**DESIGN REVIEW APPLICATION |  
REQUEST FOR RESCISSION OF DESIGN EXCEPTION**

Design Review Application **DR-23-01**  
Rescission of HRB Design Exception Request from November 14<sup>th</sup>

DESIGN REVIEW APPLICATION | DESIGN ADJUSTMENTS

Design Review Application **DR-23-01**  
Design Adjustments in Response to  
Comments from June 13<sup>th</sup>, 2023 HRB Meeting

Figure from Section 58.080.C.3

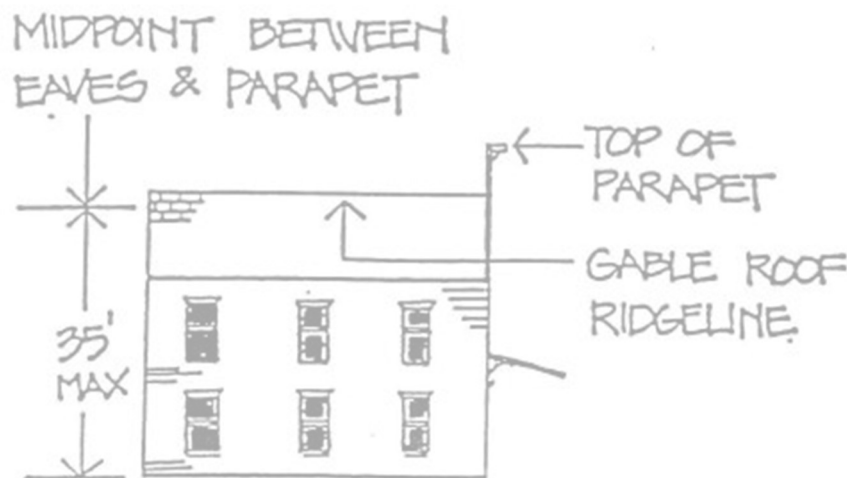
SECTION 58.080.C.3: "Building height limitations. Maximum building height shall be 35 feet (as measured by this code), and two stories. A false front shall be considered as the peak of the building if it exceeds the gable roof ridgeline."

- The height limit in the WFD district is 35' (CDC chapter 58), and is measured at grade, 5' from the front elevation (CDC chapter 41). a heavy dashed red line shows the 35' maximum height on the WFD, 12<sup>th</sup> Street, and Knapps Alley elevations. Note that while Chapter 58 allows parapets to extend above the height maximum, we have nonetheless reduced the parapet heights to fall fully beneath the 35' dimension. We are fully in compliance with the standard.
4. CONCERN: The City Engineering Department expressed concern that cast iron columns shown supporting the canopy that wraps the northwest corner of the building could conflict with utilities located beneath the sidewalk and could perhaps create an accessibility issue for pedestrians using the sidewalk.

**G GARAGE FLOOR PLAN**

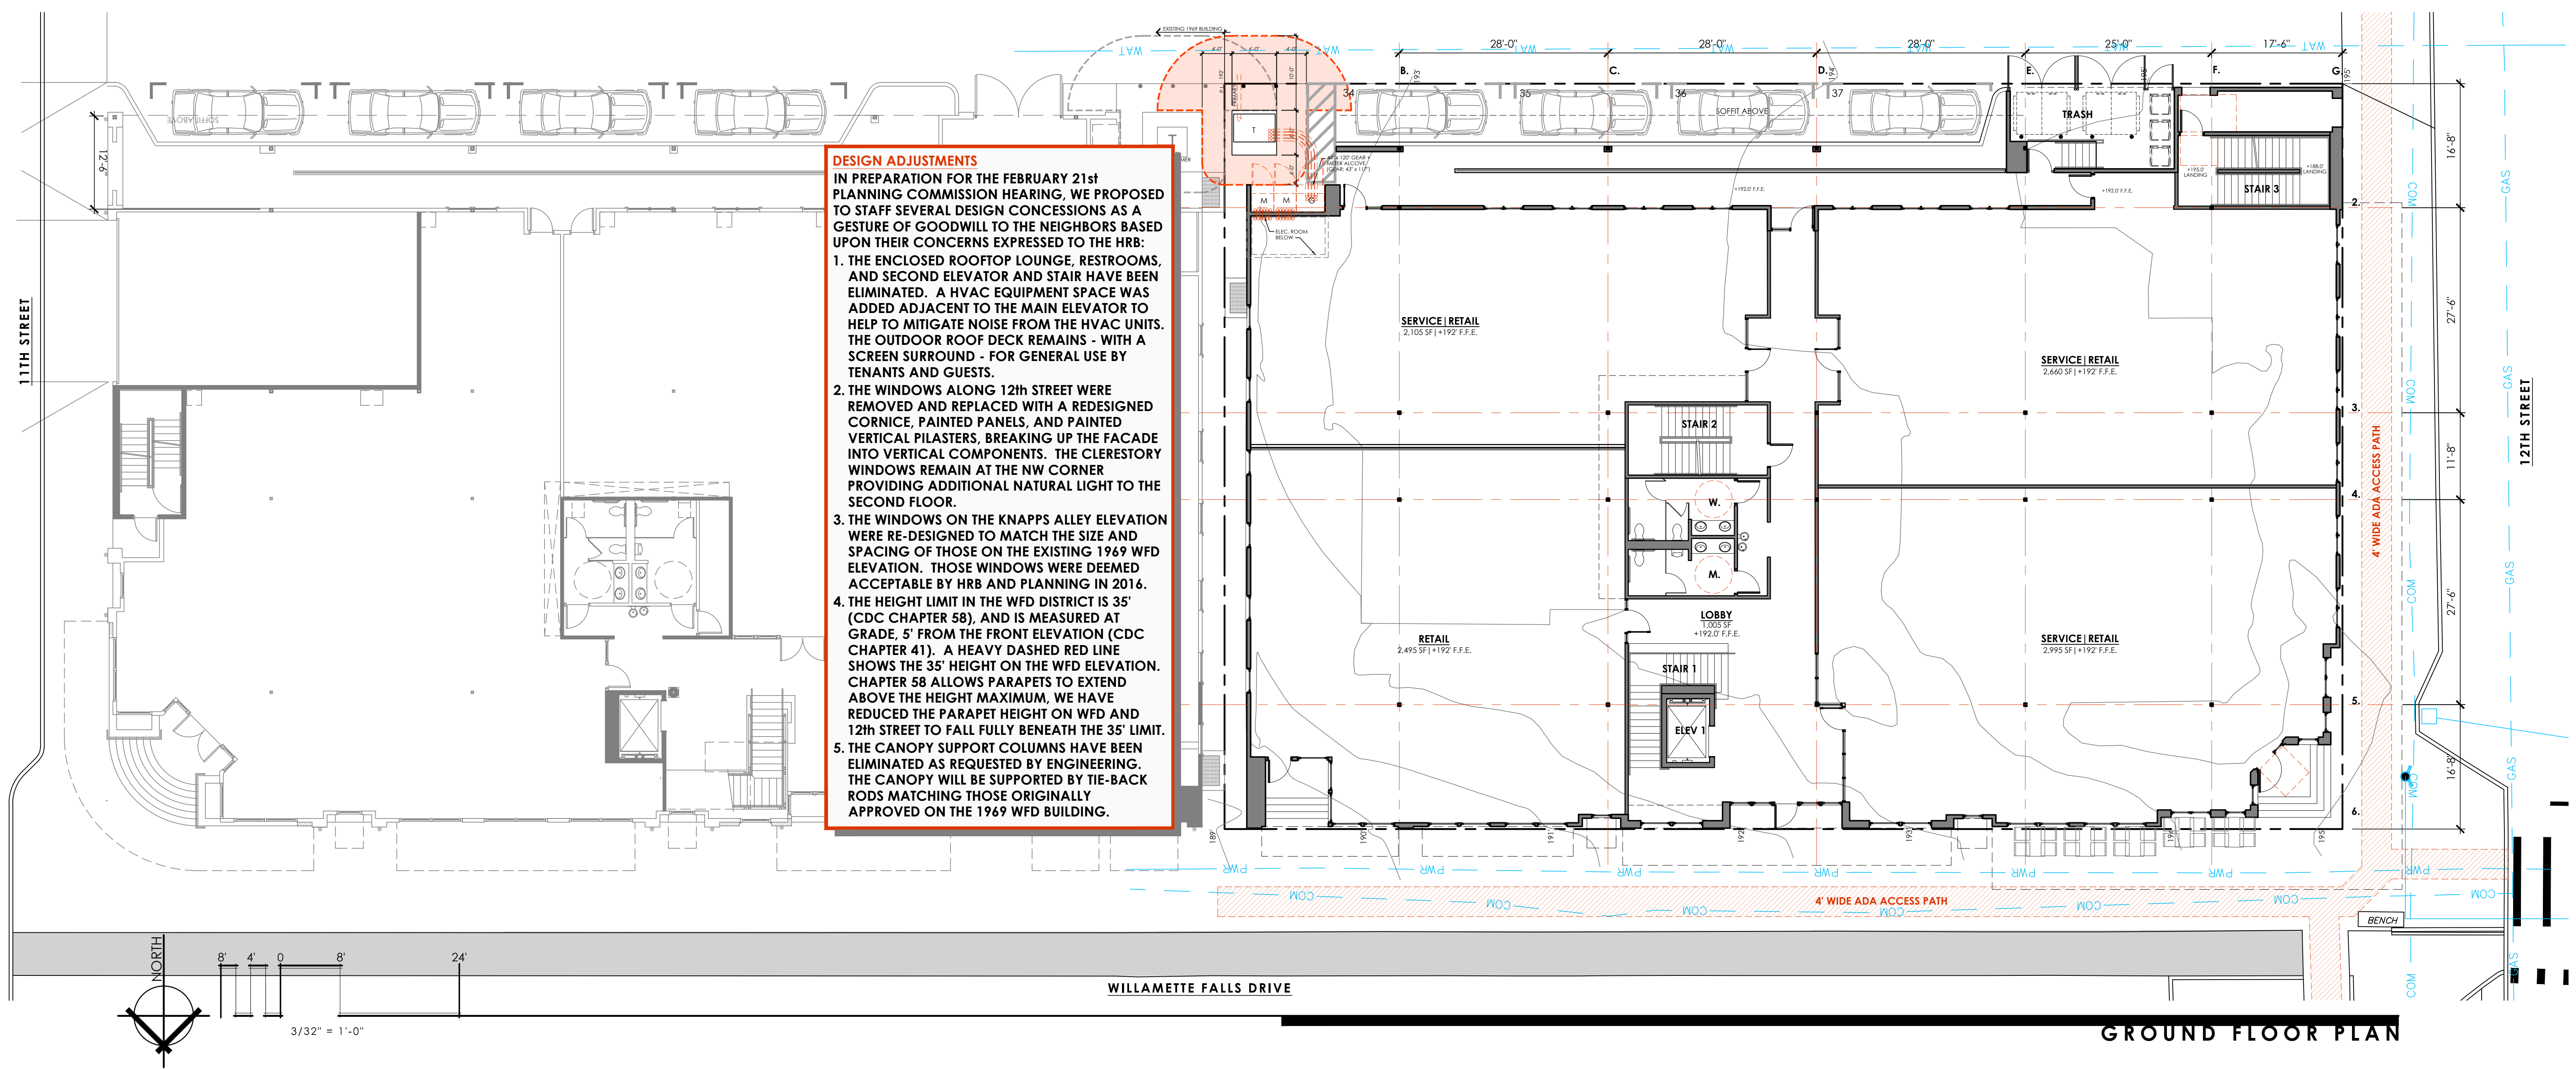
**DESIGN ADJUSTMENTS**  
 IN PREPARATION FOR THE FEBRUARY 21st PLANNING COMMISSION HEARING, WE PROPOSED TO STAFF SEVERAL DESIGN CONCESSIONS AS A GESTURE OF GOODWILL TO THE NEIGHBORS BASED UPON THEIR CONCERNS EXPRESSED TO THE HRB:

1. THE ENCLOSED ROOFTOP LOUNGE, RESTROOMS, AND SECOND ELEVATOR AND STAIR HAVE BEEN ELIMINATED. A HVAC EQUIPMENT SPACE WAS ADDED ADJACENT TO THE MAIN ELEVATOR TO HELP TO MITIGATE NOISE FROM THE HVAC UNITS. THE OUTDOOR ROOF DECK REMAINS - WITH A SCREEN SURROUND - FOR GENERAL USE BY TENANTS AND GUESTS.

**1 GROUND FLOOR PLAN + WILLAMETTE FALLS DRIVE ELEVATION**

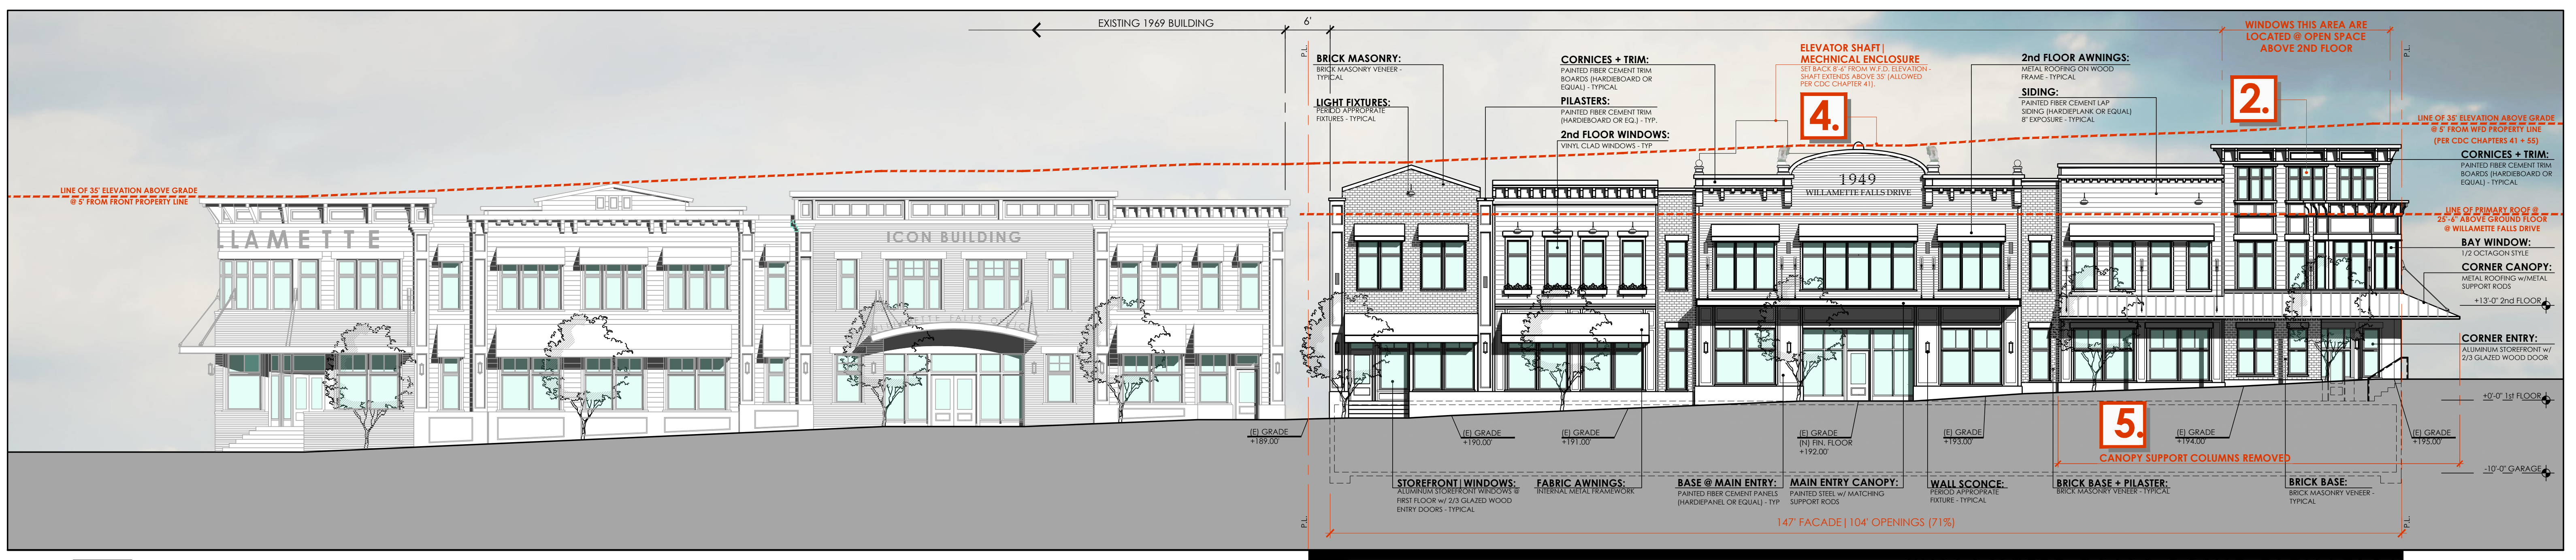
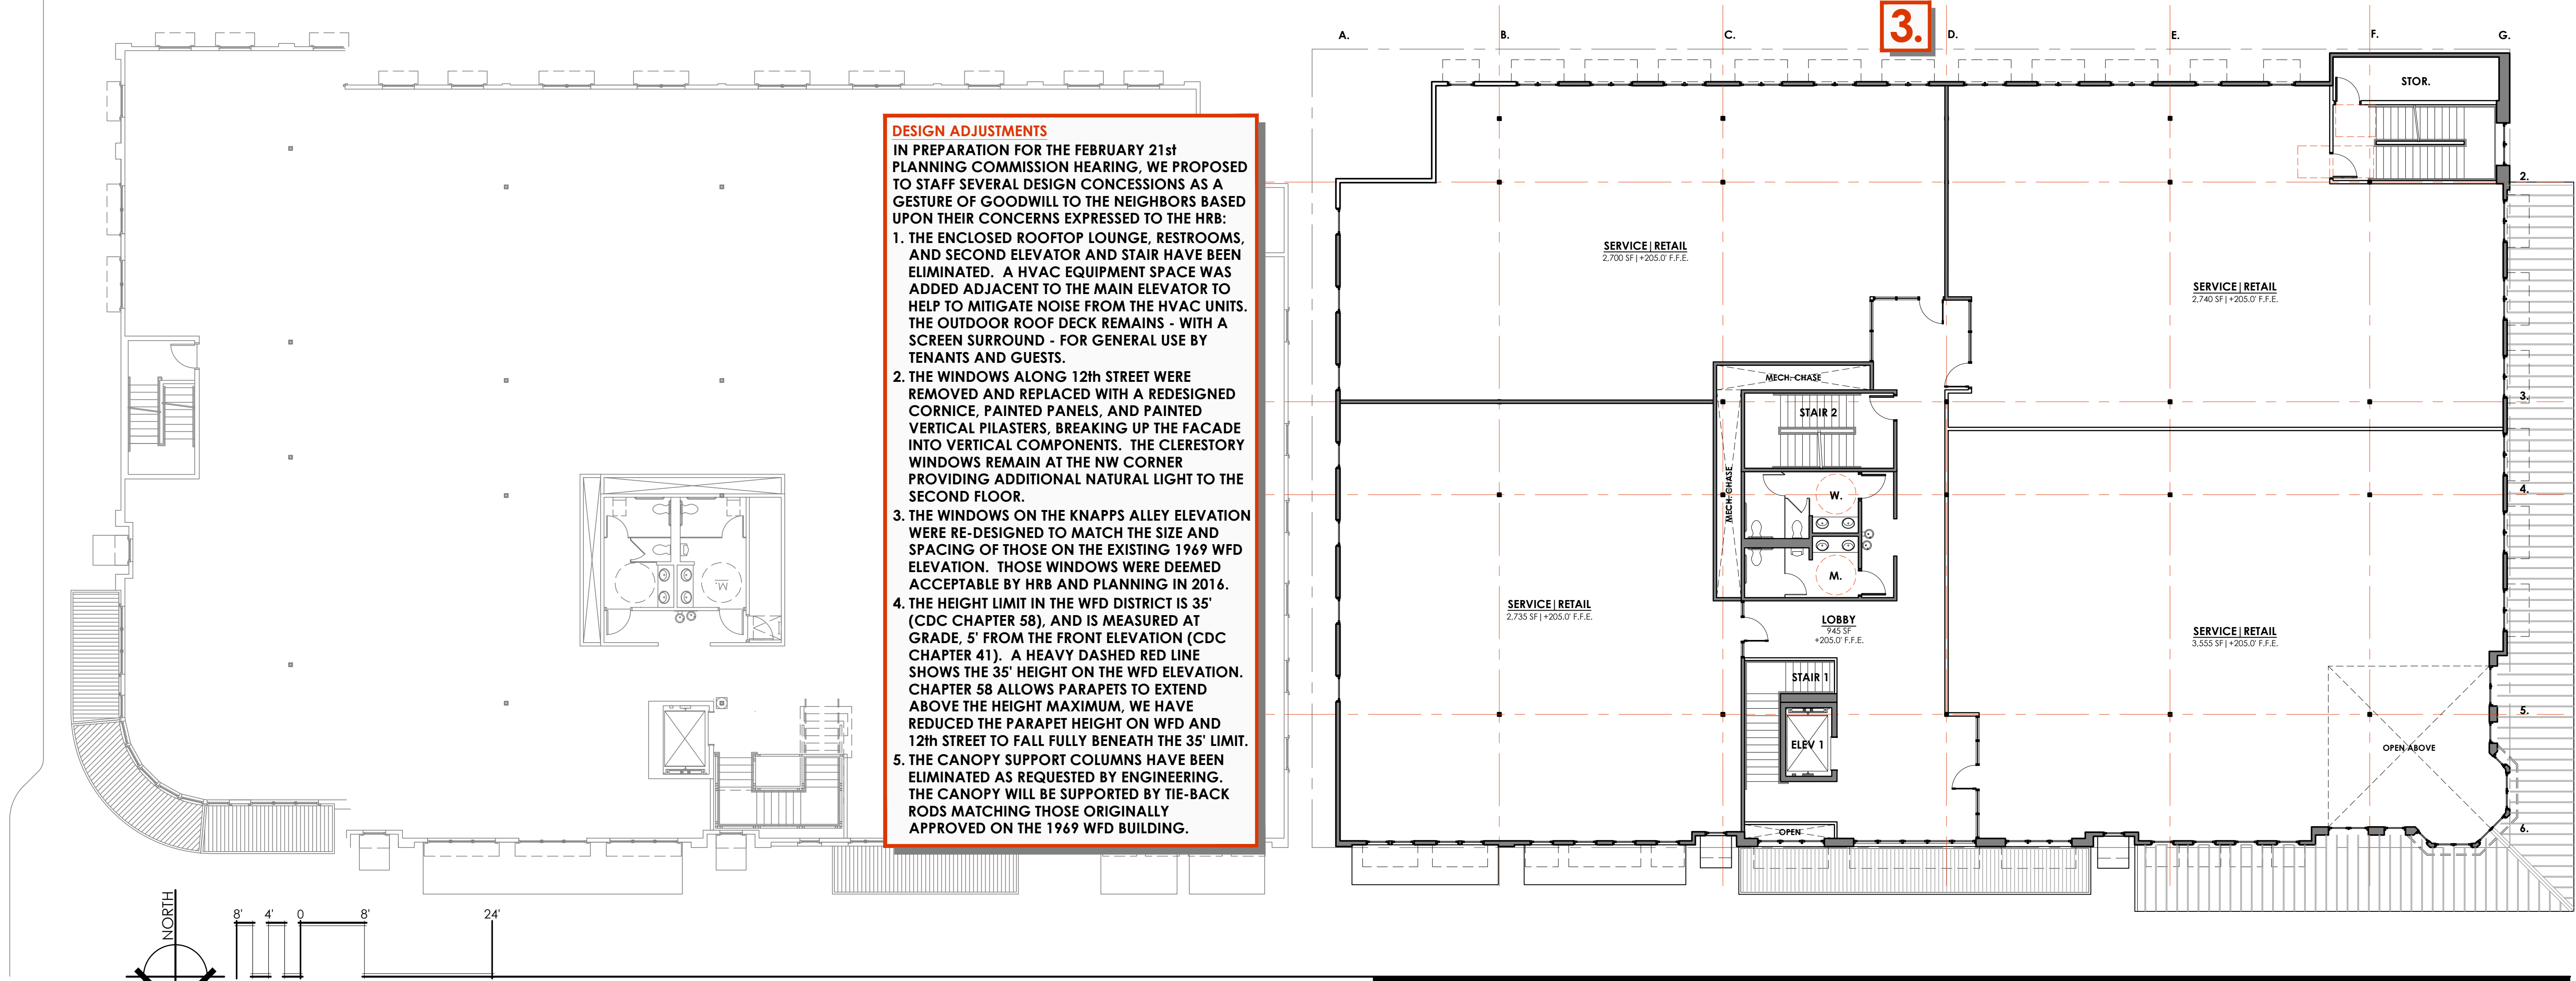
**DESIGN ADJUSTMENTS**  
 IN PREPARATION FOR THE FEBRUARY 21st PLANNING COMMISSION HEARING, WE PROPOSED TO STAFF SEVERAL DESIGN CONCESSIONS AS A GESTURE OF GOODWILL TO THE NEIGHBORS BASED UPON THEIR CONCERNS EXPRESSED TO THE HRB:

4. THE HEIGHT LIMIT IN THE WFD DISTRICT IS 35' (CDC CHAPTER 58), AND IS MEASURED AT GRADE, 5' FROM THE FRONT ELEVATION (CDC CHAPTER 41). A HEAVY DASHED RED LINE SHOWS THE 35' HEIGHT ON THE WFD ELEVATION. CHAPTER 58 ALLOWS PARAPETS TO EXTEND ABOVE THE HEIGHT MAXIMUM, WE HAVE REDUCED THE PARAPET HEIGHT ON WFD AND 12th STREET TO FALL FULLY BENEATH THE 35' LIMIT.

5. THE CANOPY SUPPORT COLUMNS HAVE BEEN ELIMINATED AS REQUESTED BY ENGINEERING. THE CANOPY WILL BE SUPPORTED BY TIE-BACK RODS MATCHING THOSE ORIGINALLY APPROVED ON THE 1969 WFD BUILDING.
